Detailed Site Plan
Departure from Design Standards
Alternative Compliance
National View

DSP-24012
DDS-24004
AC-25004

SUBJECT: Detailed Site Plan DSP-24012
Departure from Design Standards DDS-24004
Alternative Compliance AC-25004
Type 2 Tree Conservation Plan TCP2-013-2025
National View

Figure 5: Location of Recreational Facilities

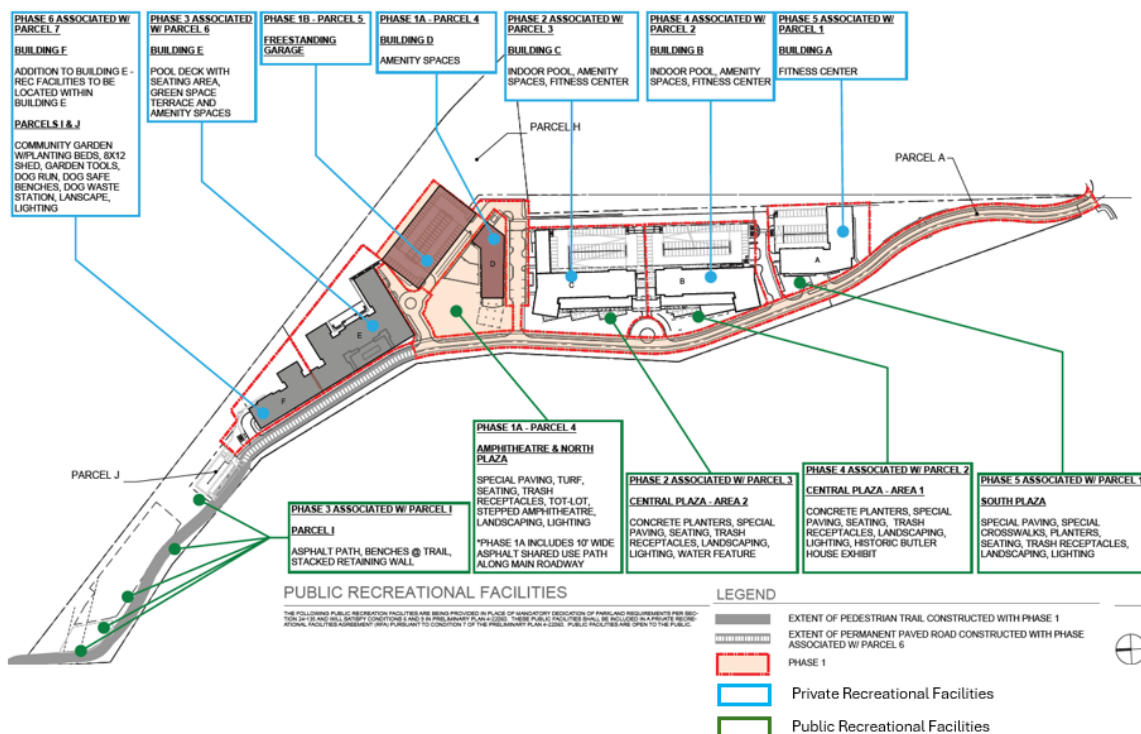
The subject DSP includes a community garden on Parcel J and a dog park on Parcel I for future residents of the development. Detailed drawings of the two locations were submitted with this DSP on Sheets L-115 and L-116. Given that the value of the 18 planting beds edging is missing in the schedule, a condition is included herein for providing it. The fenced dog park includes benches and a dog waste station; however, it lacks essential features such as a water station for dogs and owners and shade areas for comfort, in accordance with the approved 2024 *Park and Recreation Facilities Design Guidelines* (pages 156–158). A condition is included herein requiring the applicant to provide a water station and shade areas in the proposed dog park.

- (2) Add the value of edging/border for the 18 community garden planting beds to the recreational facilities schedule on Sheet A-100B.
 - (3) Provide a water station and shade areas in the proposed dog park, in accordance with the approved 2024 *Park and Recreation Facilities Design Guidelines*.

- (4) Add the value of the proposed water feature to the recreational facilities schedule on Sheet A-100B, and add the detailed drawing of this feature to the plan, with dimensions and material information.

Figure 7: Building Phasing Plan

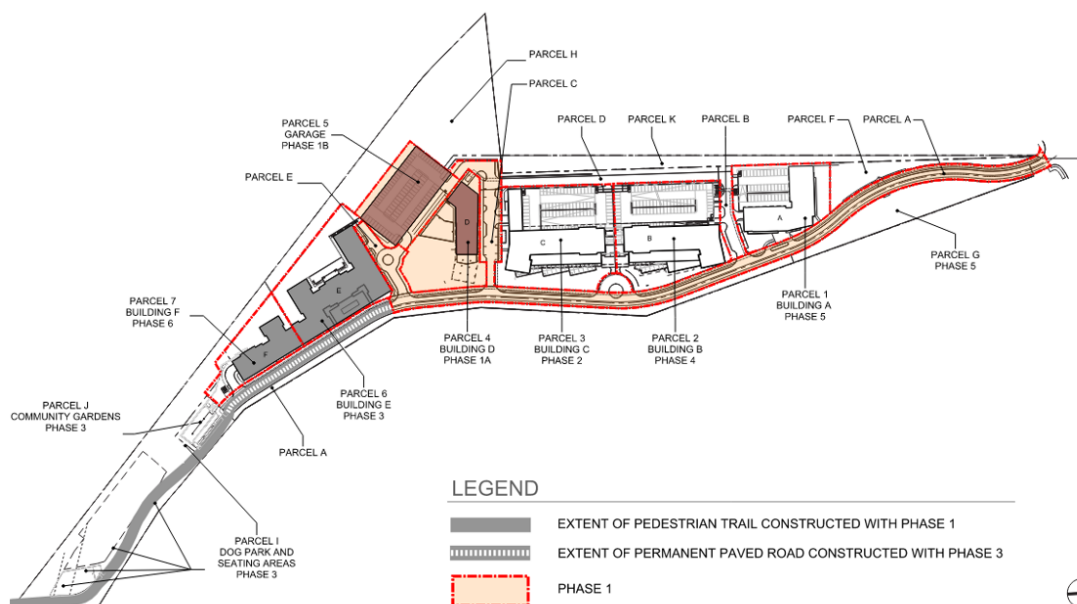
The subject DSP includes the entire development of National View. However, construction of the development will be phased, as shown on Sheet A-100. For example, Phase 1 includes construction of Private Road A (including the 10-foot-wide share-use path and street trees), Buildings D and E, and the plaza and amphitheater in front of the two buildings. Subsequent phases will be developed gradually, progressing outward from the center of the site. Each building at National View is designed as a self-sufficient entity, allowing for effective integration of subsequent phases. The area where each phased building is located and developed will also include essential features to support a degree of self-sufficiency. The construction time of some parcels is missing on Sheet A-100. A condition is included herein requiring the applicant to note the construction timing of those parcels.

- (2) Identify Americans with Disabilities Act (ADA) compliant curb ramps at all vehicular crossings.
- q. Revise Sheet A-100 to ensure that all parcels are included within a dedicated construction phase.
